Access Compliance Report

Public Rights-of-Way

(Curb Ramps)

Intersection ID: 27411	Main Street: BALLANTYNE_COMMONS_PY	Cross Street: BALLANTYNE_CORPORATE_PL	Location: SE
ADA ID: EF457DF5F130	Ramp Type: Perp	Initial Pass/Fail: Pass	Overall Compliance: No
Severity Score: 22.5			
Codes/Mitigation Info/Possible Solution		Field Measurements/Component Compliance

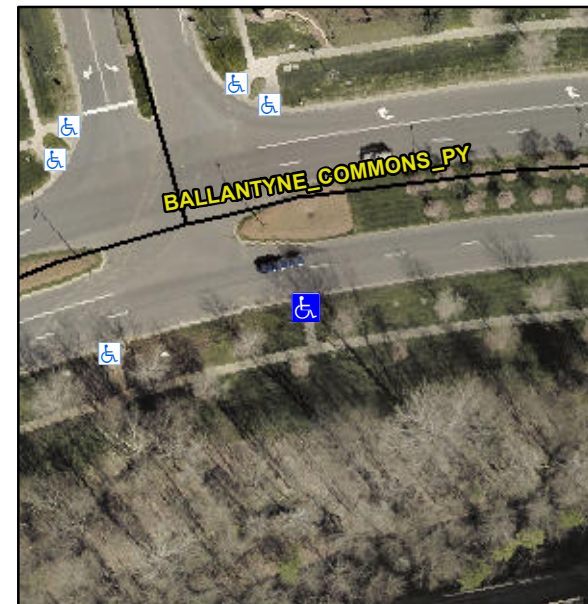
Not Found, R305, R302.7.2, R304.5.4

Compliance	Description	Data	Compliance	Description	Data
N/A	Ramp Length (in)	130.0	Yes	Ramp Slope (%)	6.4
Yes	Ramp Width (in)	48.0	Yes	Ramp XSlope (%)	1.2
N/A	Flare Type LT	Sloped	N/A	Flare Type RT	N/A
N/A	Flare Slope LT (%)	7.5	Yes	Flare Slope RT (%)	2.6
N/A	Flare Traversable LT?	Yes	N/A	Flare Traversable RT?	Yes
Yes	Landing Length (in)	77.0	No	DWS Provided?	No
Yes	Landing Width (in)	59.0	N/A	DWS Contrast?	No
Yes	Landing Slope (%)	1.3	N/A	DWS Length (in)	N/A
Yes	Landing X Slope (%)	2.1	N/A	DWS Full Width?	No
N/A	Landing Curb? (Y/N)	No	N/A	DWS Offset (in)	N/A
N/A	Shared Landing?	No			
Yes	Gutter Ponding?	No	No	Gutter Slope (%)	5.4
No	Gutter Lip Ht (in)	0.5	Yes	Gutter X Slope (%)	2.3
N/A	Painted X Walk1?	No	N/A	Painted X Walk2?	N/A
	X Walk 1 Direction	To N		X Walk 2 Direction	N/A
N/A	X Walk 1 Width (in)	N/A	N/A	X Walk 2 Width (in)	N/A
	X Walk 1 Slope (%)	4.2		X Walk 2 Slope (%)	N/A
	X Walk 1 X Slope (%)	2.9		X Walk 2 X Slope (%)	N/A

**Remove & Replace Entire Ramp.
Remove & Replace Gutter.**
